minutes of the 42nd meeting of Technical Committee held on 10.5.95 at 4.00 P.M. in the Conference Hall of 'B' Block, Vikas Sadan, INA, New Delhi.

The following thirteen items were discussed in the Technical Committee.

Sub : Proposed bridge on River Yamuna to connect Delhi with NOIDA.
F(24)92+F.5(15)87-MP

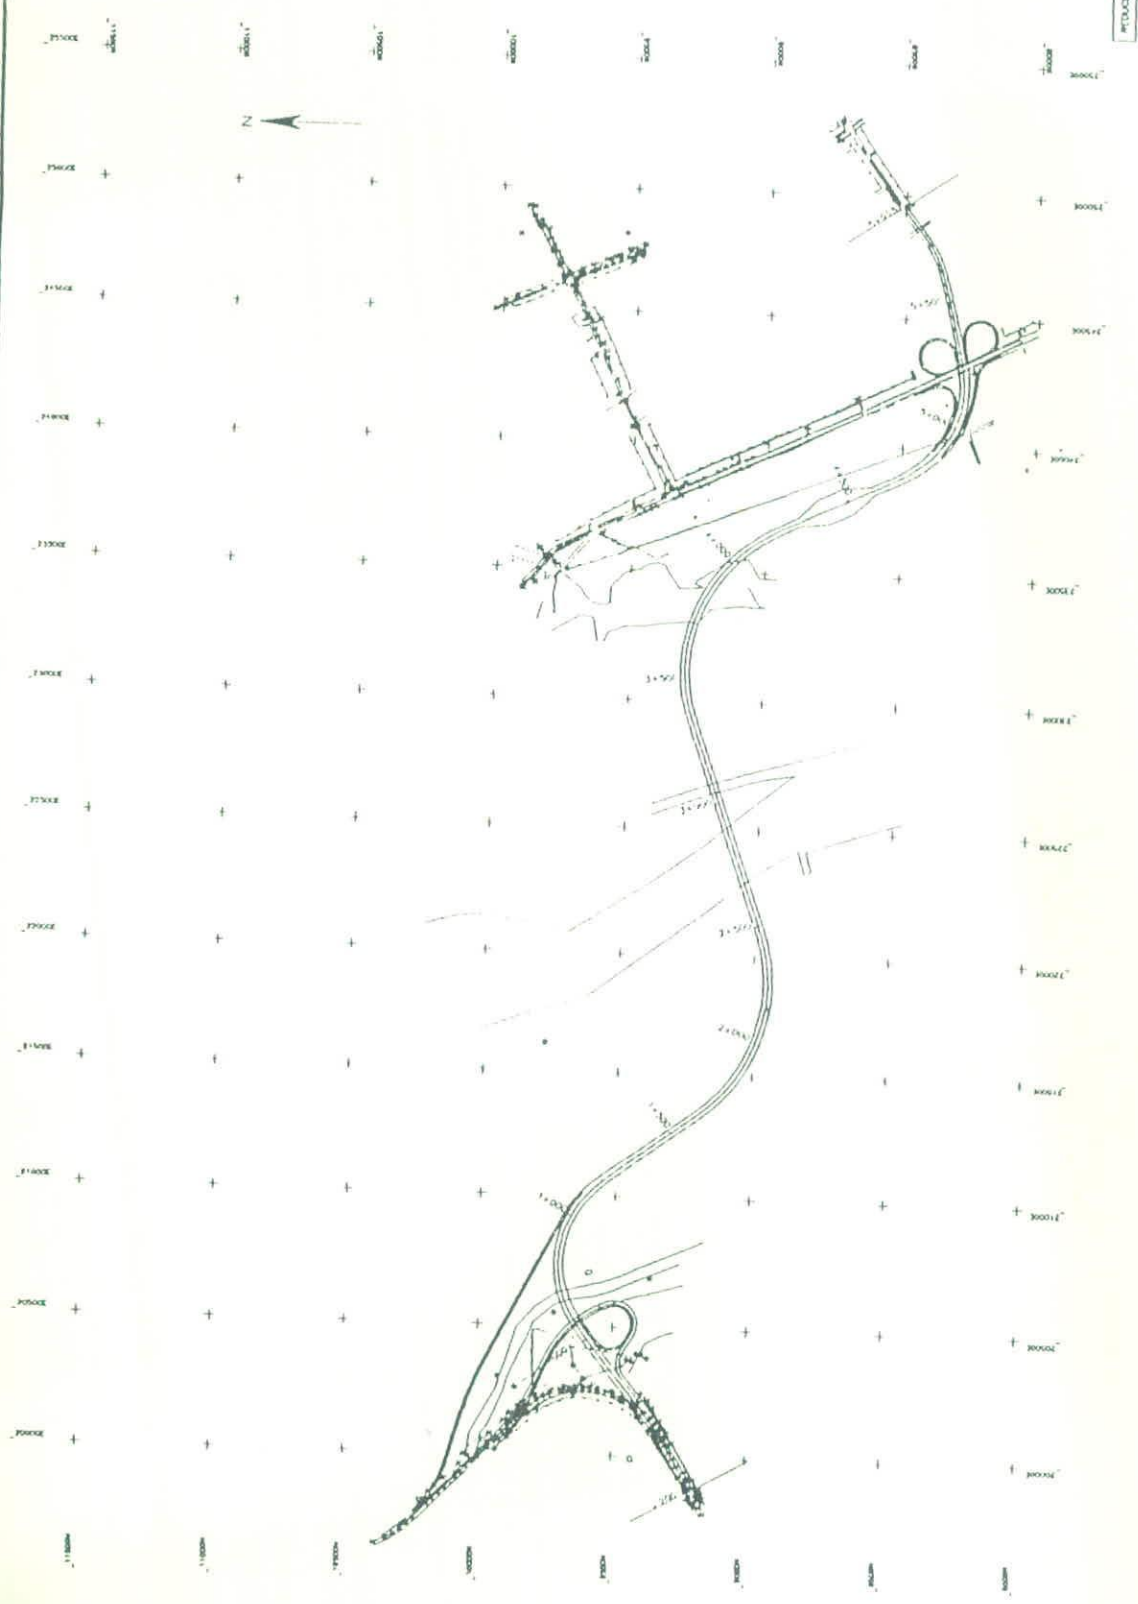
(i) The alignment plan earlier approved by Steering Committee under the Chairmanship of Secretary, MOUA&E has also been agreed by Technical Committee of DDA. Although from the letter sent by IL&FS, it is understood that the changed alignment has been discussed by Principal Secretary (Industry) and Chairperson, NOIDA but there is no member of the GNCTD involved in this regard who is one of the 3 members as per the Memorandum of Association for the implementation of this project.

(ii) The alignment plan and design of the inter-sections and interchange on both sides of the bridge have not been worked out keeping in view the surrounding network in the vicinity and its effect there on. In fact, earlier Chief Engineer, YBP while submitting the scheme had communicated that this link should be fully synchronised with the Mathura - Ashram Chowk - NH By-pass 2 and discharge from Barapullah Nallah also. The same has not been worked out.

(iii) The landscape plan for the clover-leaf junction has not been submitted.

3. In view of above, the final alignment and dispersal arrangements as enclosed with your letter under reference are approved and the same may be put up to the Technical Committee in its next meeting.
